**PARK CITY MUNICIPAL CORPORATION
HISTORIC PRESERVATION BOARD
CITY COUNCIL CHAMBERS
July 19, 2017**

Author: Hannah M. Tyler, Planner
Subject: Reorientation and Material Deconstruction Review
Address: 424 Woodside Avenue
Project Number: PL-16-03379
Date: July 19, 2017
Type of Item: Administrative – Reorientation (Rotation and Lifting) and Disassembly/Reassembly (Panelization)

Figure 2a: *Proposed Reorientation – West Façade*

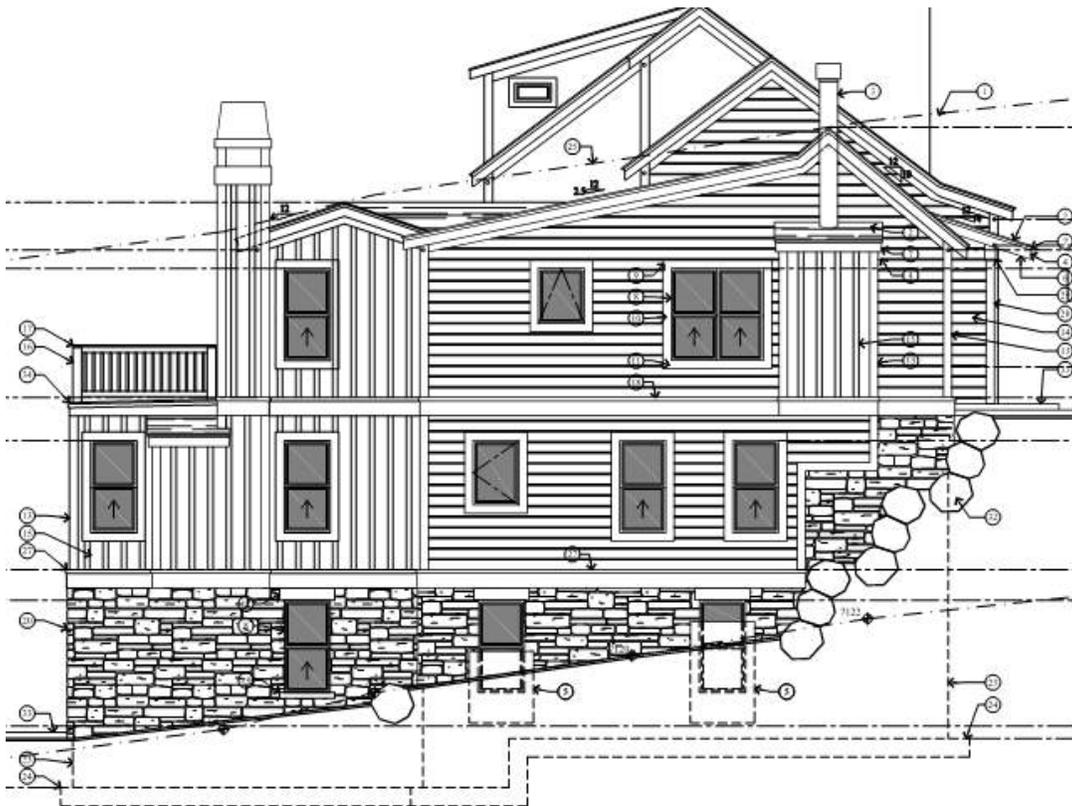
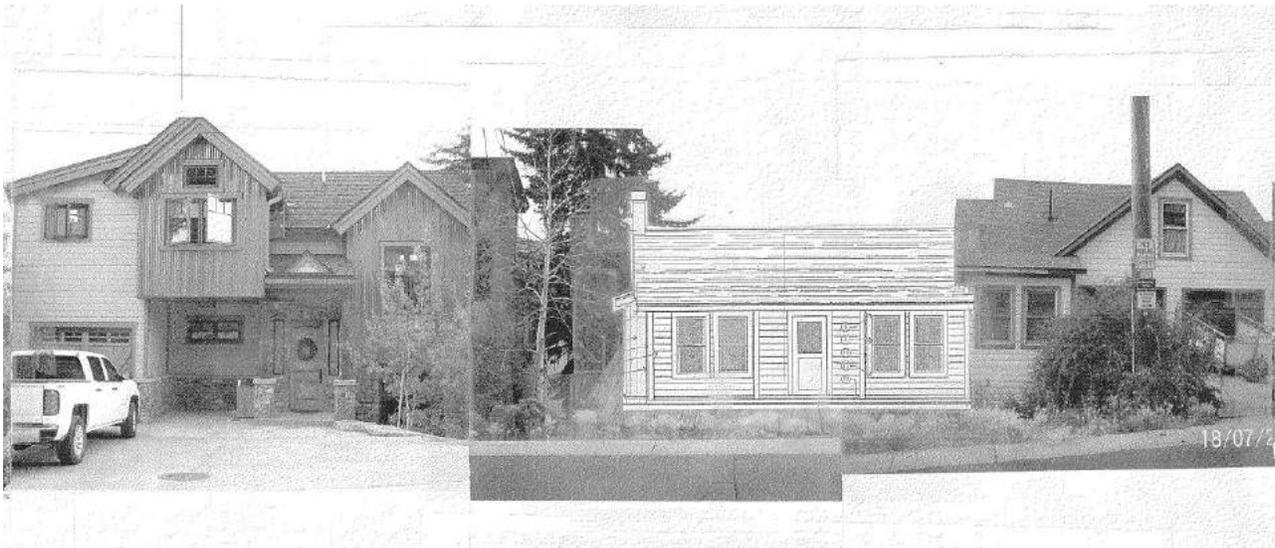
- if a portion of the historic building encroaches on an adjacent property and an easement cannot be secured **Not applicable**; or
- if relocating the building onto a different site is the only alternative to demolition **Not applicable**; or
- if the Planning Director and Chief Building Official determine that unique conditions warrant the relocation or reorientation on the existing site **Does not comply.**

- if a licensed structural engineer certifies that the building cannot reasonably be moved intact **Does not comply**; or
- if disassembly/reassembly is the best alternative to demolition **Does not comply**; or
- if the building is determined by the Chief Building Official to be a hazardous or dangerous building, pursuant to Section 115.1 of the International Building Code **Does not comply**; or
- if the Planning Director and the Chief Building Official determine that unique conditions and overall quality of the historic preservation effort warrant the disassembly/reassembly of part or all of the building **Does not comply**, AND
- if it is to be accurately reassembled in its original form, location, placement and orientation **Complies**.

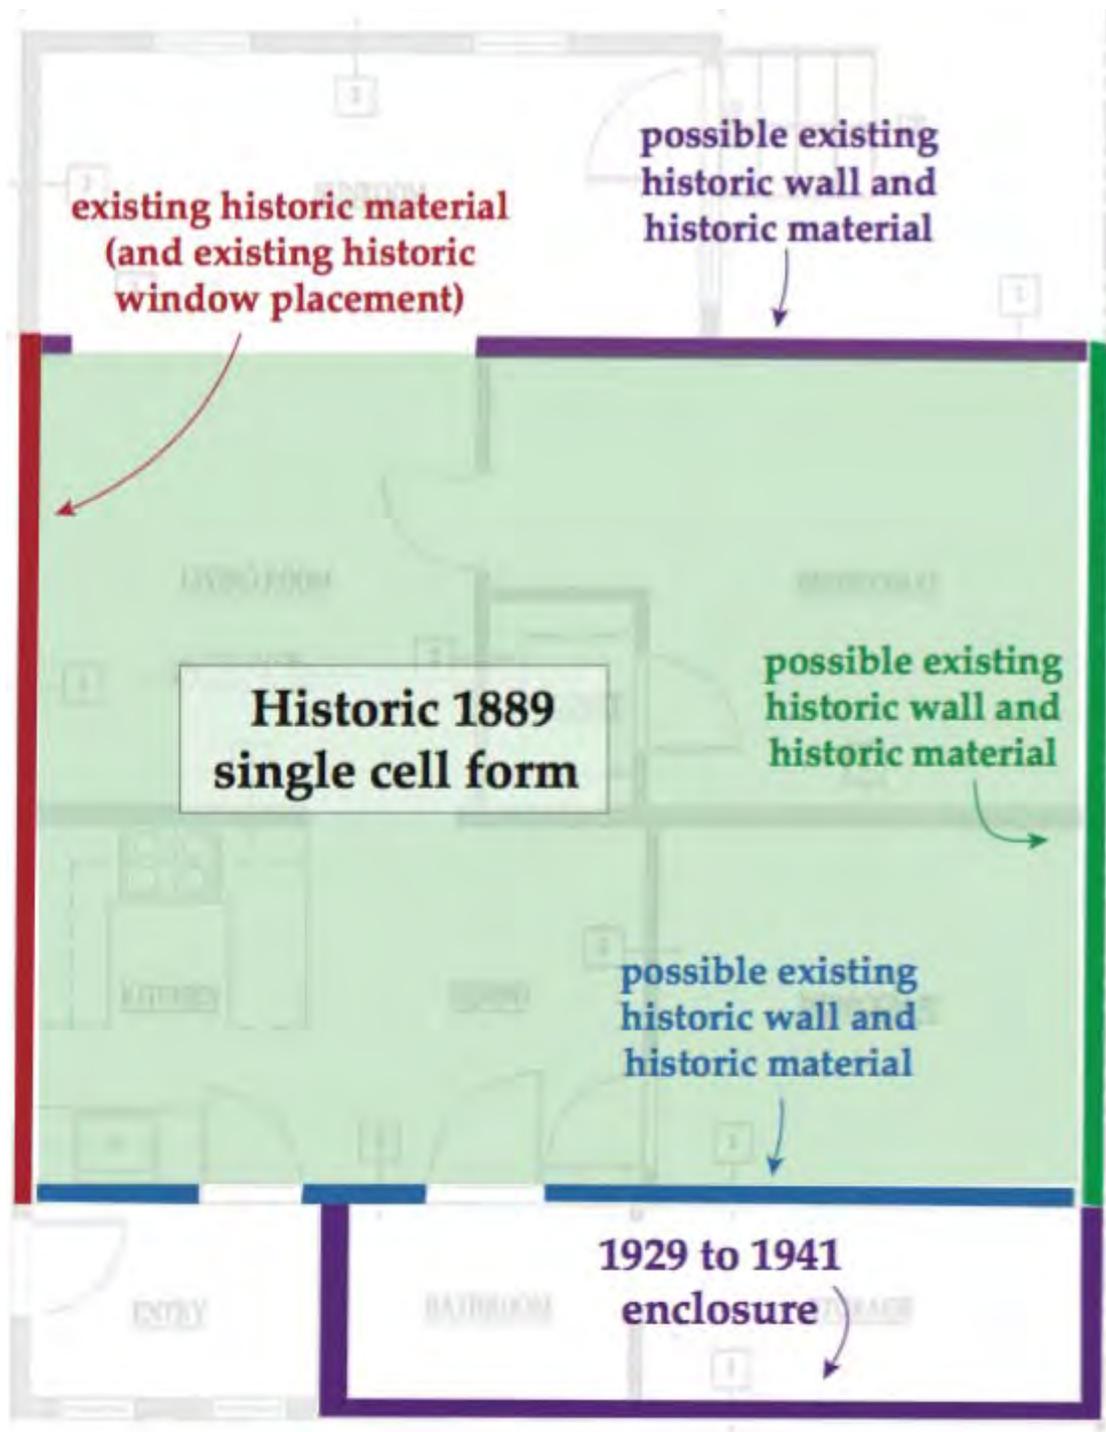
(Comment # 4.) *The "historic form", as it is currently situated in its historic location, historic orientation, and historic relationship to (a story below) Woodside Avenue is astonishingly "a visually prominent element along the street" (A rare day passes that a pedestrian -- tourist, skier just off the mountain -- does not hesitate at 424 Woodside to photograph the structure.). There are less invasive*

measures than "raising [to the proposed 9'] and rotating the historic form" that could **better** "improve the appearance of the historic form" (Raising the structure the recommended 2' -- in its historic location and orientation -- would "improve the appearance of the historic form"). The "presence [of historic 424 Woodside] along Woodside Avenue" does not need to be "reestablished" because its presence has, in fact, been solidly established since 1889. 424 Woodside does not need to be made "once again a valuable asset to the district" because the historic structure, as it currently stands, strongly relays historic life on a steep hillside of a booming mining town.
